Subject: RE: Kerr McGee Site NDEP Data Gaps

Subject: Kerr McGee Site NDEP Data Gaps

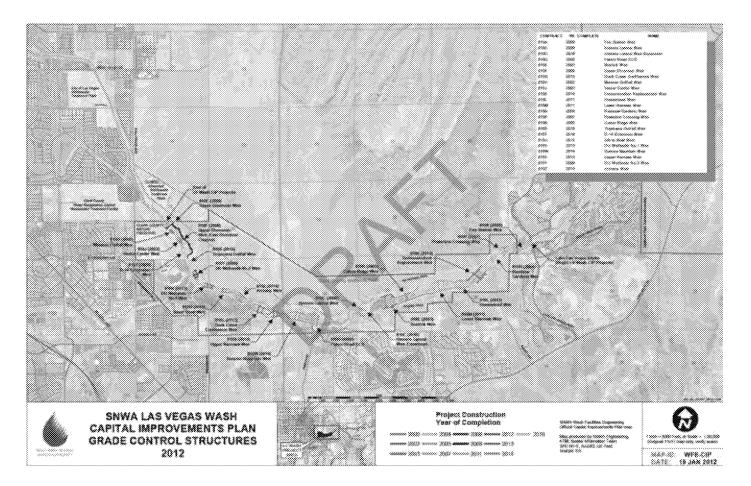
development. NDEP should work with the City of Henderson and relevant redevelopment agencies to identify such locations. One such area may be a recently re-graded (since 2012) area near the Henderson wastewater treatment ponds (yellow polygon on figure at right)
